Subject: AP1000 COL Standard Technical Report Submittal of APP-GW-GLN-131 (TR 131),
Revision 0

“Miscellaneous AP1000 Design Changes”

Technical Report 131 addresses a few miscellaneous design changes made to AP1000 that are incorporated into Revision 16 of the Design Control Document.

Figure
2.3.11-1
Gaseous Radwaste System

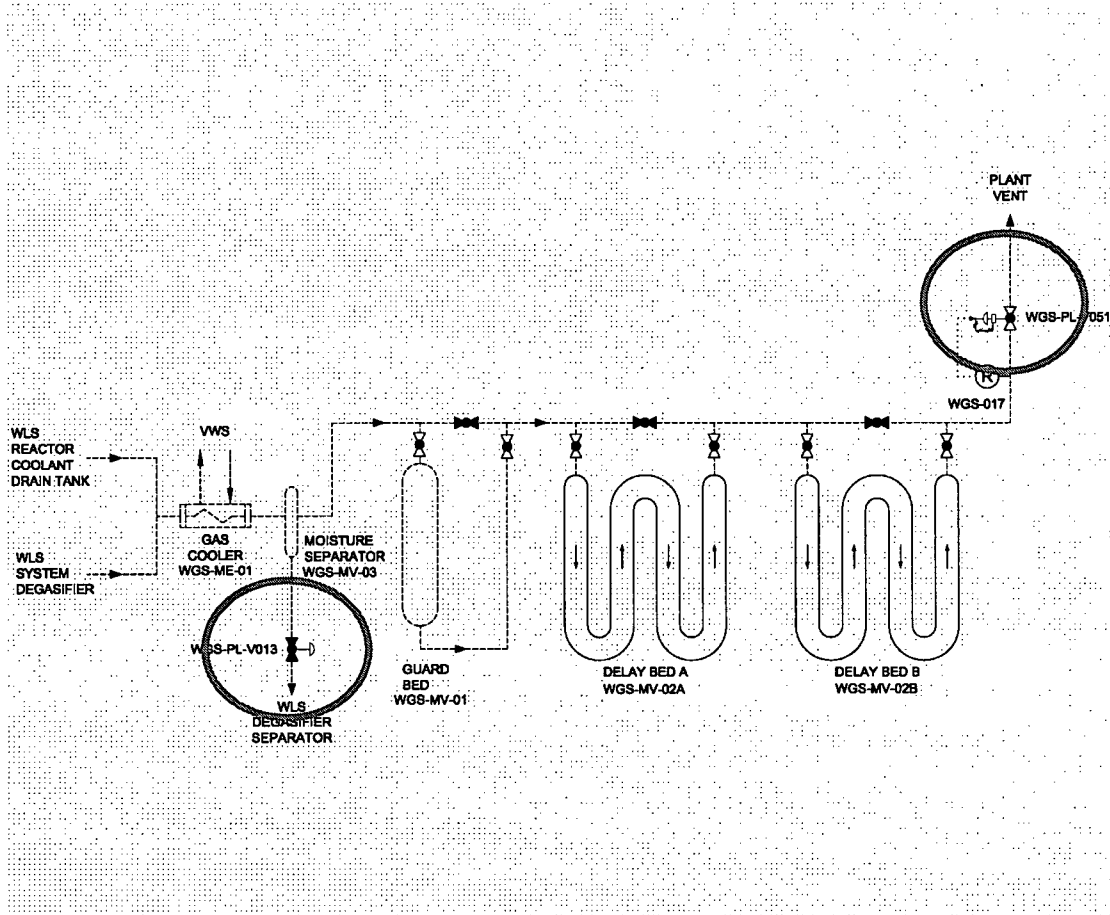
Change 1: WGS Simplified Sketch Corrections

The current version of the Gaseous Radwaste System (WGS) simplified sketch shown in the DCD does not accurately depict the current status of the WGS design. The sketch will be updated to reflect the current AP1000 WGS design by correcting the valve type for the discharge valve and the moisture separator drain valve.

Figure 9.5.1-1 (Sheet 3 of 3)

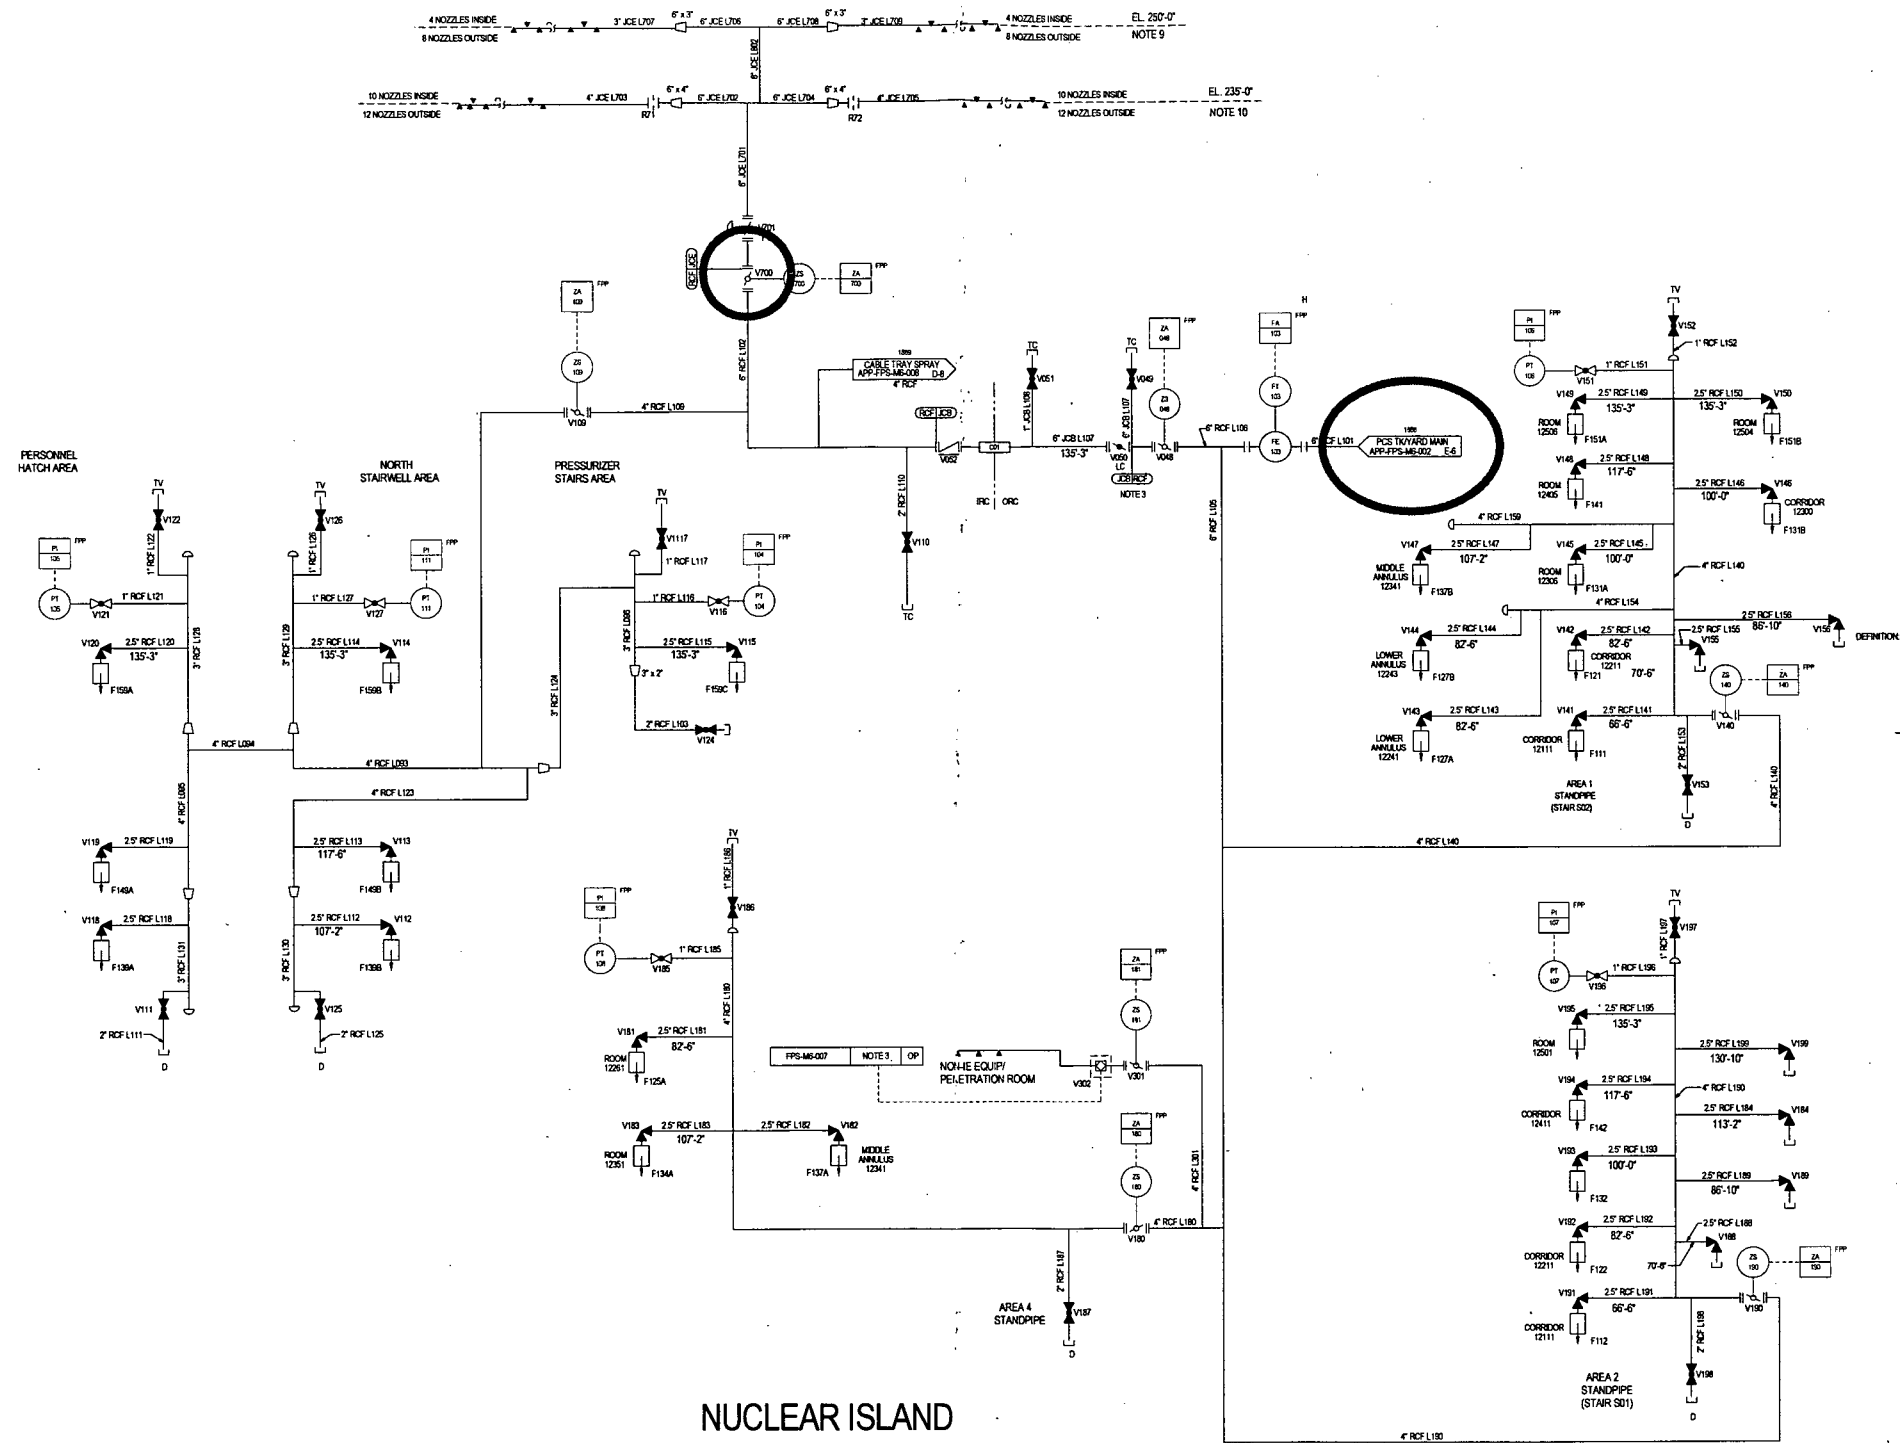
Change 7: Correction to Sheet 3 of Figure 9.5.1-1

The current figure is incorrect in the following ways:

- Valve V102 is incorrectly labeled, it should be valve V700
- Flag coming from "FPS TANK" is changed to show its correct origin
